UNITED STATES PATENT AND TRADEMARK OFFICE

APPLICATION NO.	FILING DATE	FIRST NAMED INVENTOR	ATTORNEY DOCKET NO.	CONFIRMATION NO.
10/817,609	04/02/2004	Michael W. Pfeiffer	STL11386	2452

Office Action Summary**Application No.**

DETAILED ACTION

FIG. 7

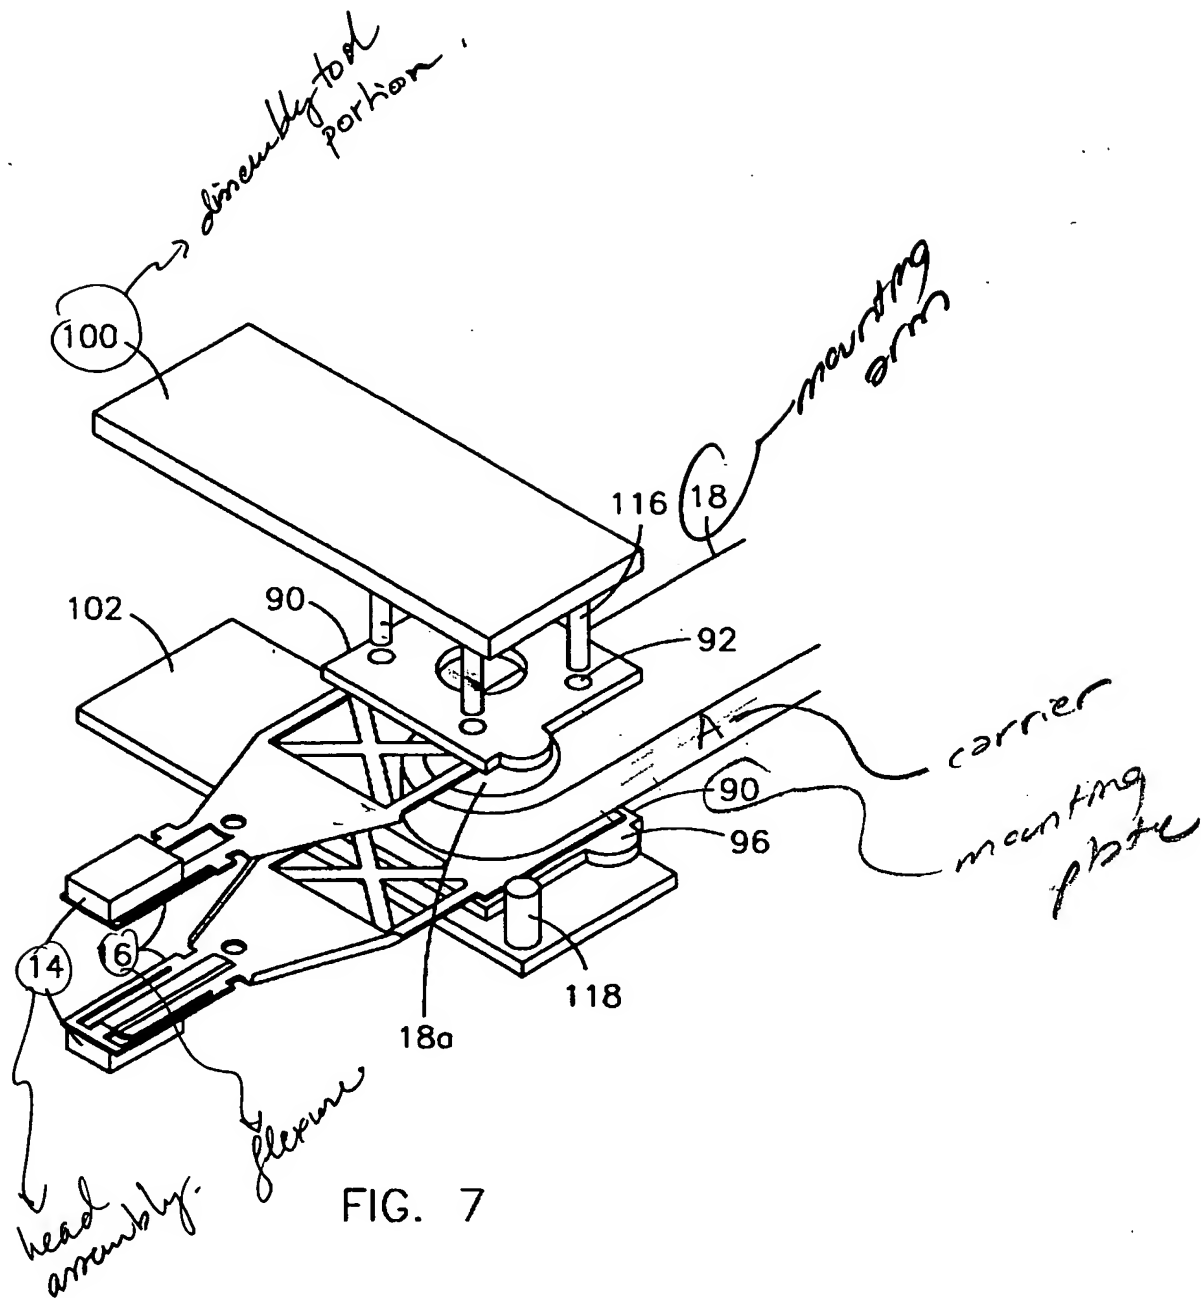
As applied to claims 1, 2, 9 and 12, Budd discloses an apparatus comprising a carrier (e.g. 18, Fig. 7) adapted to protect a head stack assembly comprising a cantilevered flexure (e.g. 16) which supports a transducer attached to sliders at a distal end thereof, the carrier comprising a carrier support surface arranged to continuously, contactingly support the distal end of the flexure adjacent the transducer and to permit a subsequent engagement of a medial portion of the flexure by a merge tool (e.g. 100,

102) which disengages the flexure from the carrier support surface (1 16A-1 16B) while merging the transducer with a recording surface.

As applied to claim 11, Budd discloses the merge tool in combination with the carrier (see Fig. 7).

As applied to claim 13, Budd discloses the carrier further comprises a retention feature which engages an edge of the head assembly (e.g. 14) to retain the carrier on the head stack assembly (see Fig. 7).

As applied to claim 16, Budde discloses wherein the carrier (A< Fig. 7) further comprises an elongated body having a medial portion that extends adjacent the medial portion of the flexure (16) and a distal end which support the carrier support surface (see Fig. 7).
